Office Action Summary

10/633,450

HARTY, ROBERT D.

DETAILED ACTION

FIG. 1

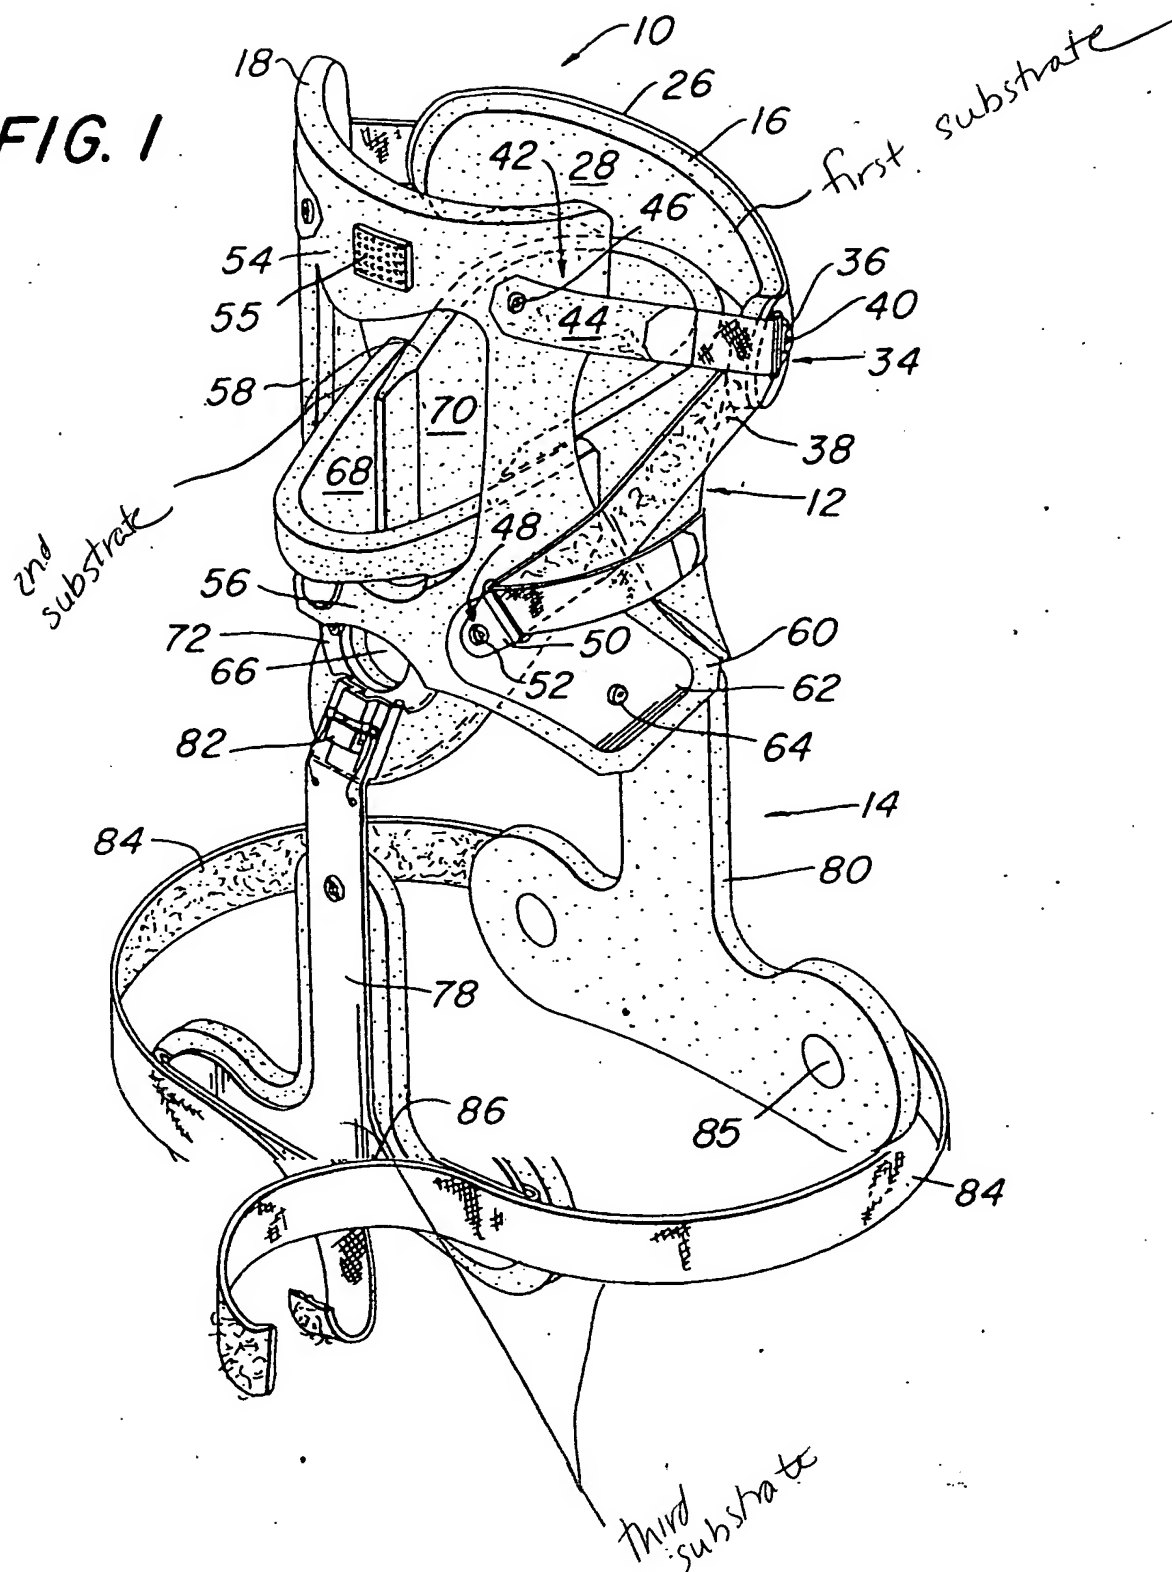
As regards claim 1, Calabrese et al. disclose a medical collar that anticipates applicant's invention. The collar immobilizes the head, neck and upper torso of a patient, and as can be seen from marked-up Fig. 1, comprises a first substrate for supporting the back of the patient's head; a second substrate in communication with the first substrate, whereby the second substrate is adapted to encircle the patient's neck;

and a third substrate in communication with the second substrate, whereby the third substrate contacts the patient's chest.

FIG. 24

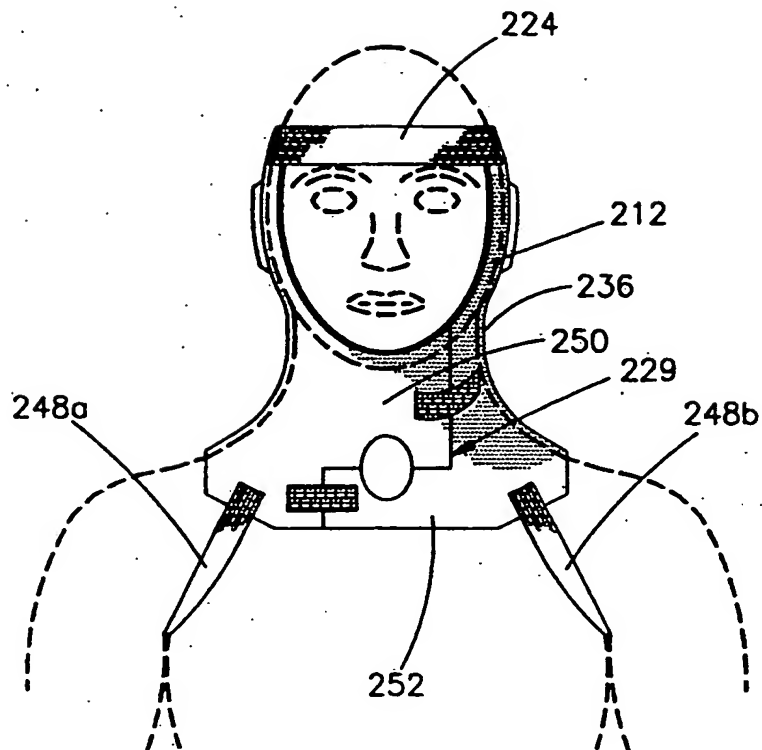
As regard claim 1, Schmidt discloses a support device that immobilizes the head, neck and upper torso of a patient, and as can be seen from marked-up Figs. 24 and 25, comprises a first substrate for supporting the back of the patient's head; a second substrate in communication with the first substrate, whereby the second substrate is adapted to encircle the patient's neck; and a third substrate in communication with the second substrate, whereby the third substrate contacts the patient's chest.
